**NEW YORK STATE THRUWAY AUTHORITY  
DEPARTMENT OF ENGINEERING**

**AMENDMENT NO. 2  
TO**

**CONTRACT TANY 24-8  
D214964  
2" MILL AND INLAY, SAFETY  
IMPROVEMENTS AND MISCELLANEOUS WORK  
BETWEEN MILEPOST 47.6+/- AND MILEPOST 60.1+/-  
IN THE NEW YORK DIVISION  
OF THE NEW YORK STATE THRUWAY  
IN ORANGE COUNTY**

| TITLE OF DRAWING<br>MISCELLANEOUS DETAILS |   | DRAWING NUMBER:<br>MD-5       |

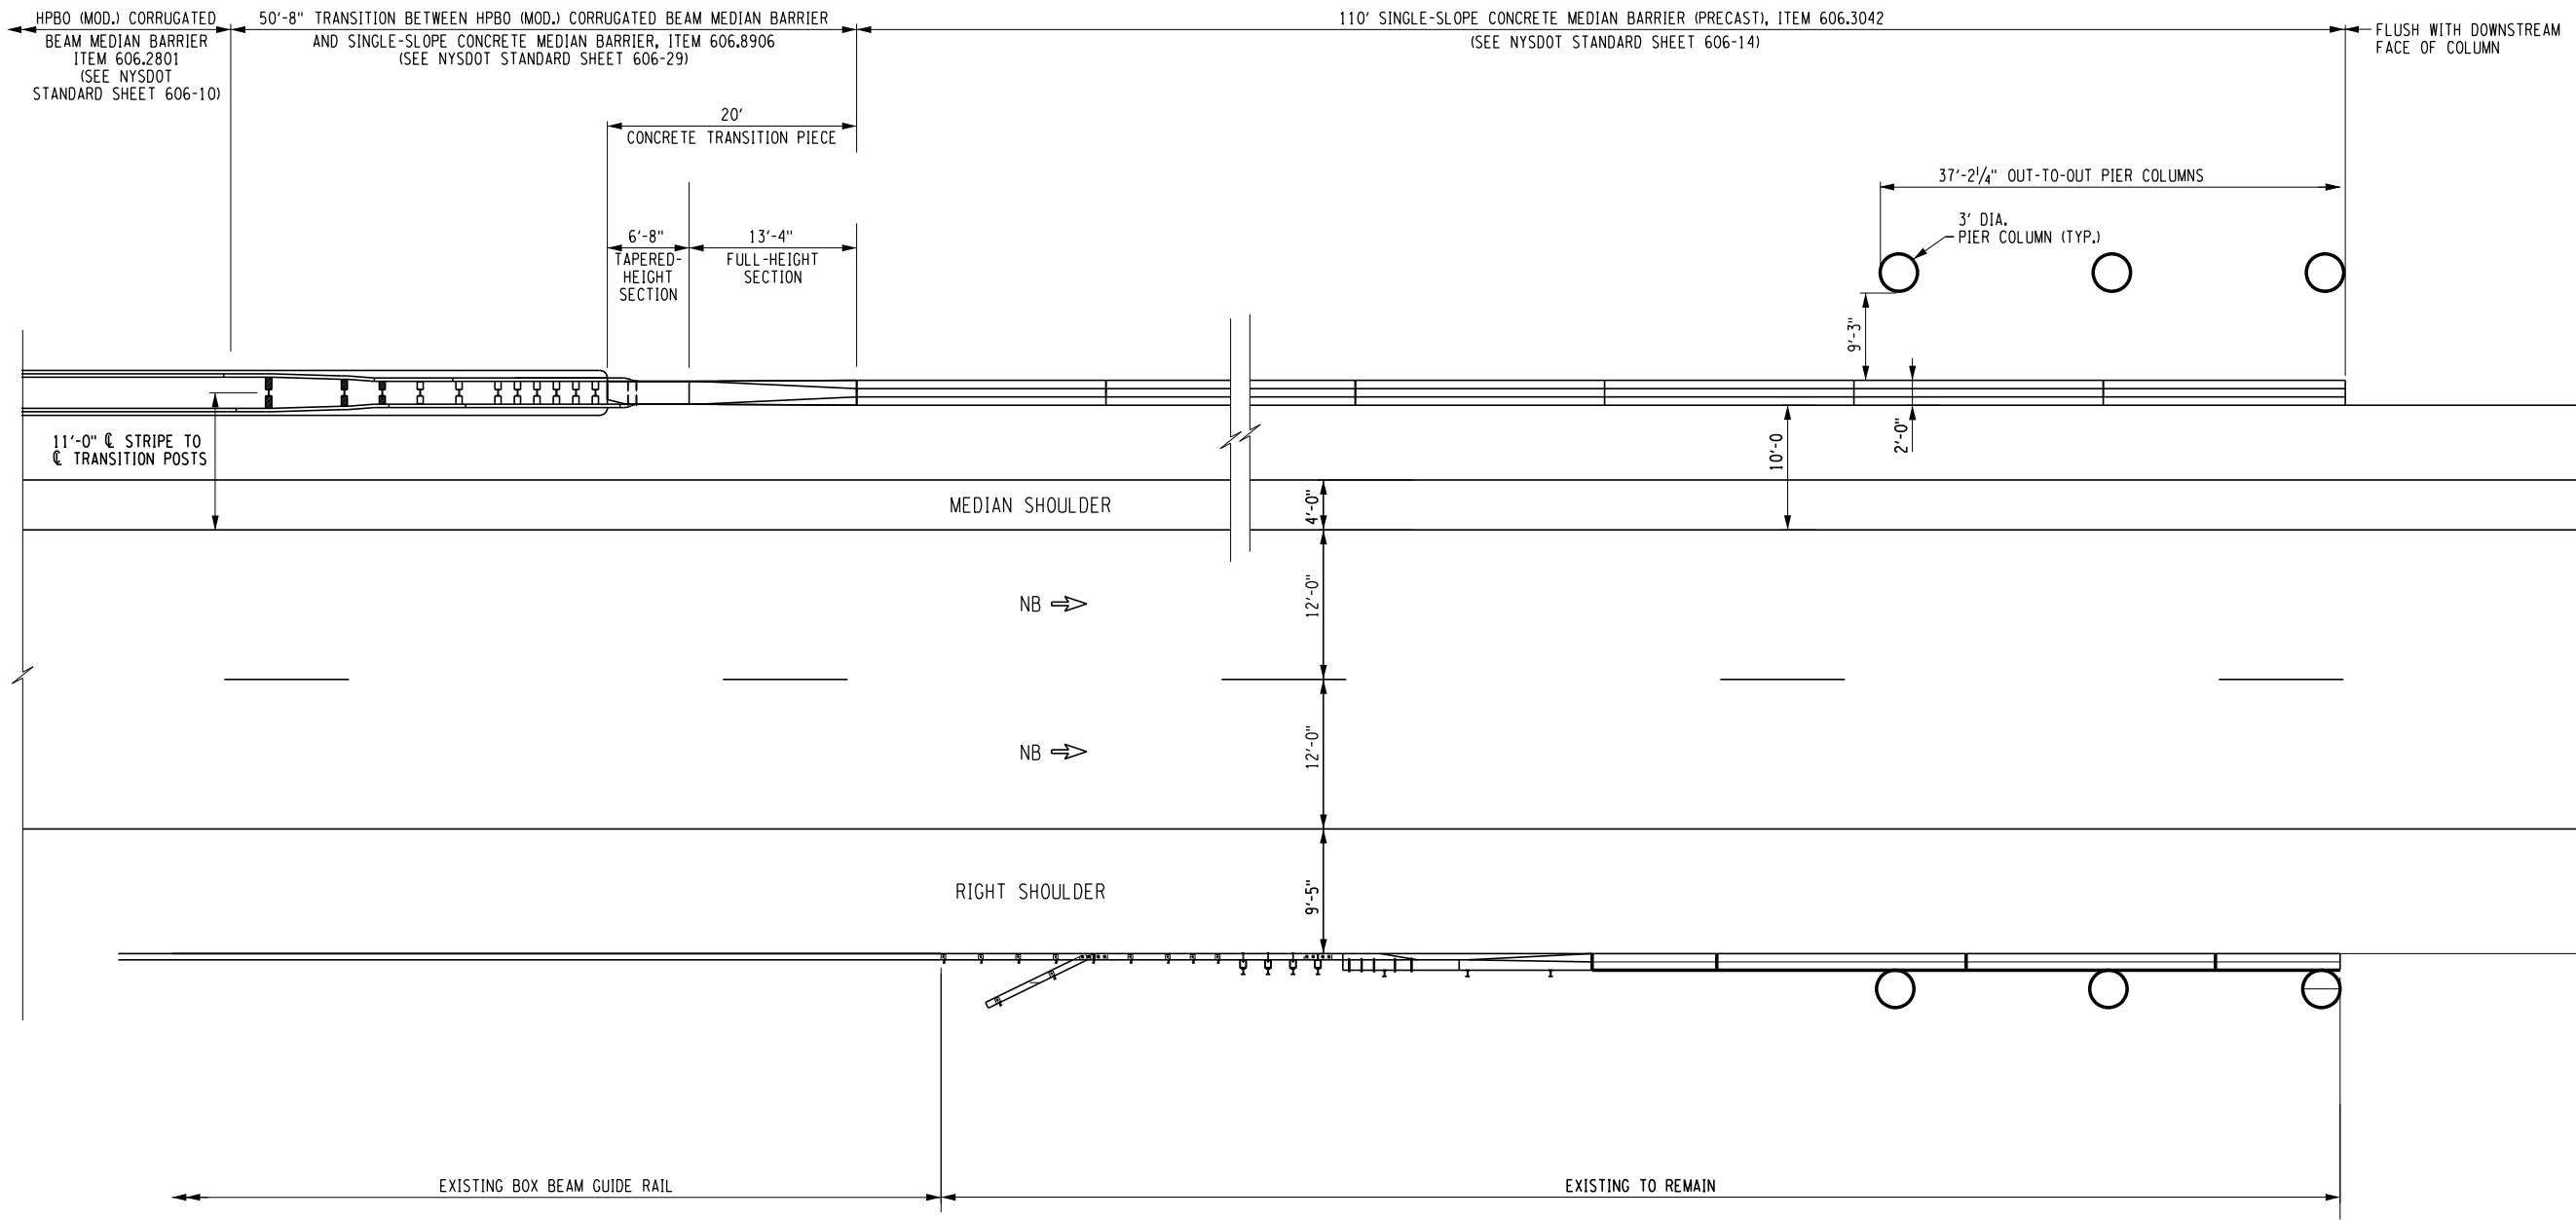
6. **DELETE** Drawing Number MD-5, Sheet 64-A1 of 108, and **SUBSTITUTE** with the attached Drawing Number MD-5, Sheet 64-A2 of 108. The proposed Northbound right Pleasant Hill Rd. concrete barrier has been changed to “EXISTING TO REMAIN”.

TITLE OF PROJECT: PAVEMENT RESURFACING AND SAFETY IMPROVEMENT  
 LOCATION OF PROJECT: NY DIVISION MP 48.0 TO 60.1  
 TITLE OF DRAWING: GENERAL PLAN

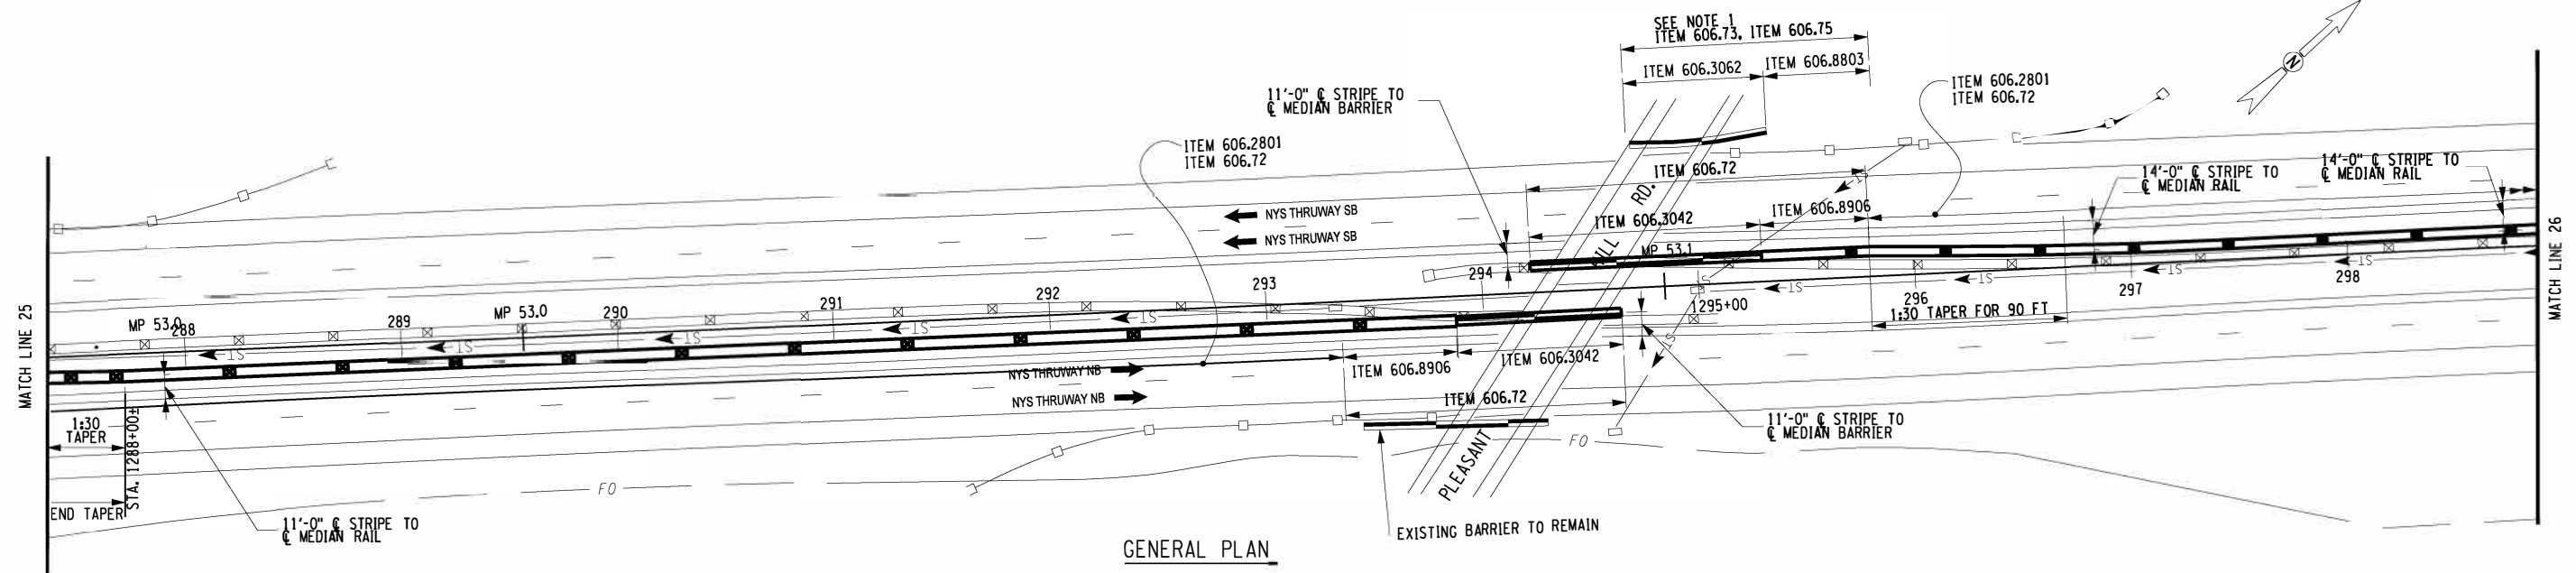
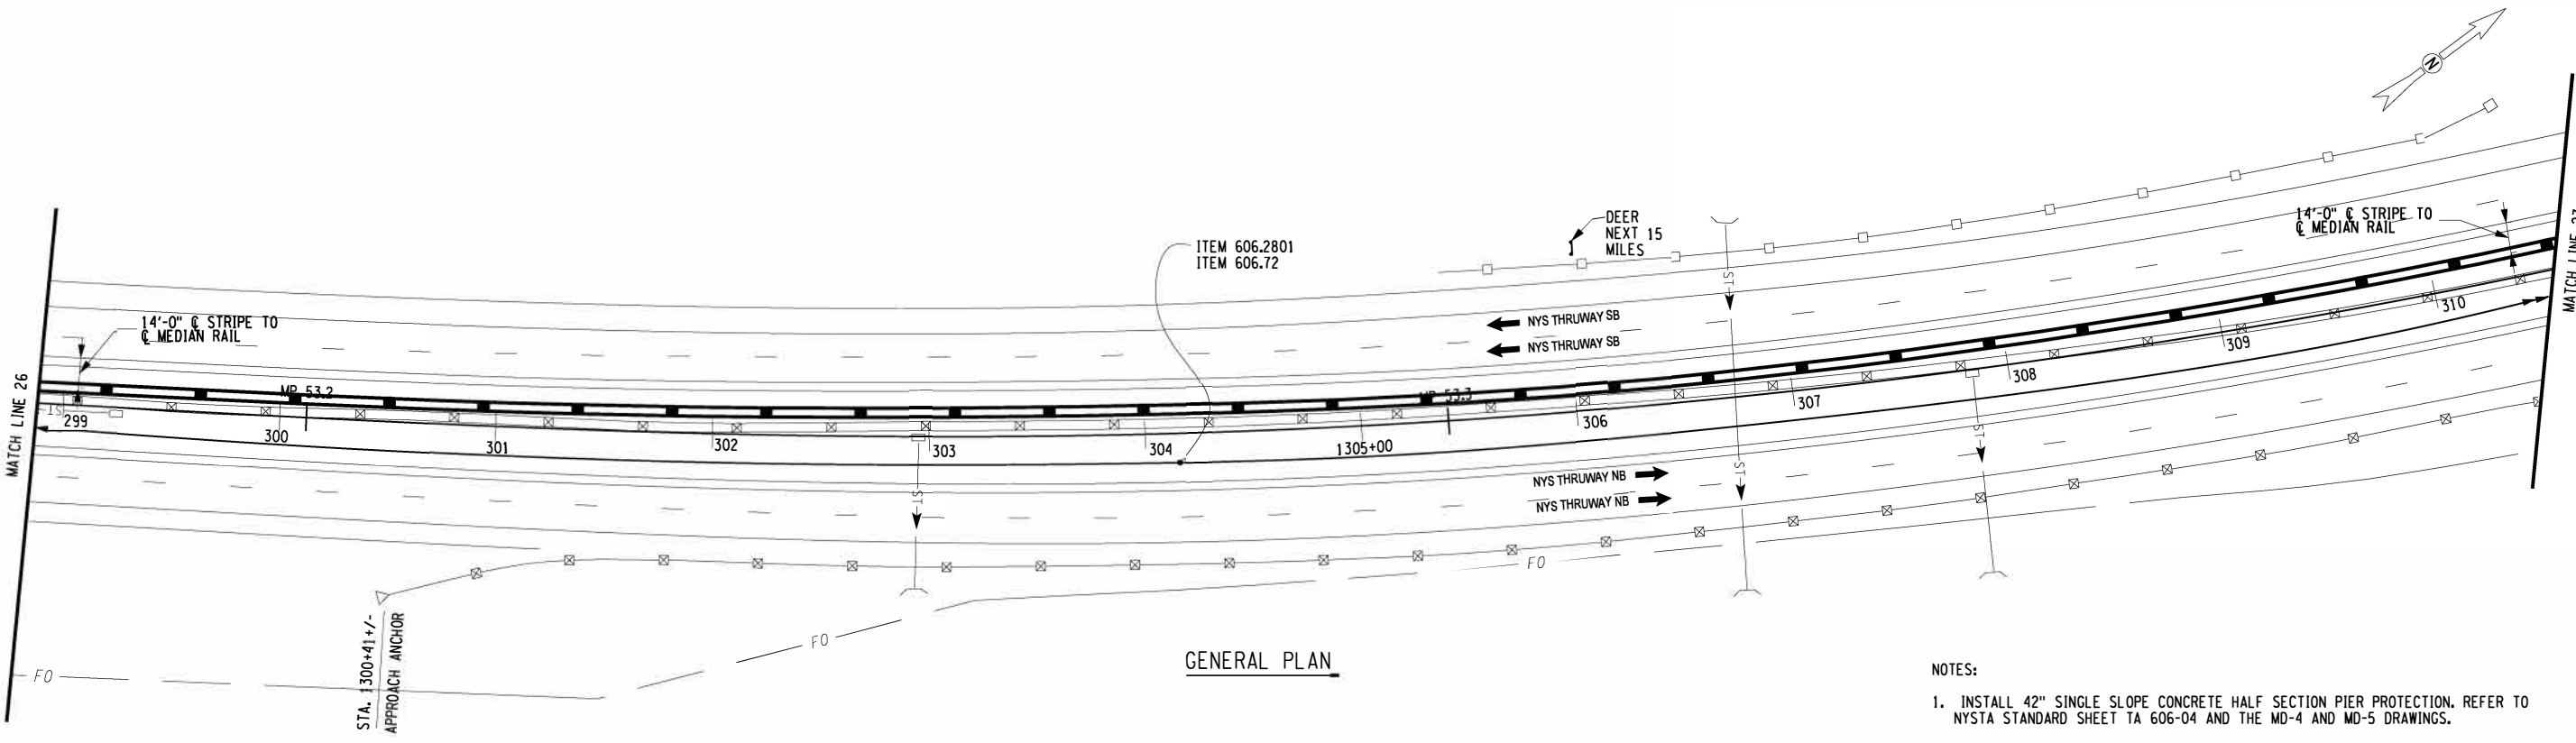
7. **DELETE** Drawing Number GP-15, Sheet 86-A1 of 108, and **SUBSTITUTE** with the attached Drawing Number GP-15, Sheet 86-A2 of 108. The proposed Northbound right Pleasant Hill Rd. concrete barrier has been changed to “EXISTING TO REMAIN”.
8. On Drawing Number GP-29, Sheet 100-A1 of 108, **DELETE** reference to “90” in the on the upper right-hand corner of the drawing where it currently reads “THIS SHEET SUPERSEDES SHEET 90” and **REPLACE** with “100”, so it reads “THIS SHEET SUPERSEDES SHEET 100”, instead. This was an inadvertent typographical error. In addition, **ADD** an “A1” after “100” on the same upper right-hand corner to denote that Sheet 100-A1 is an amended sheet. The dash is omitted only because of space limitations.
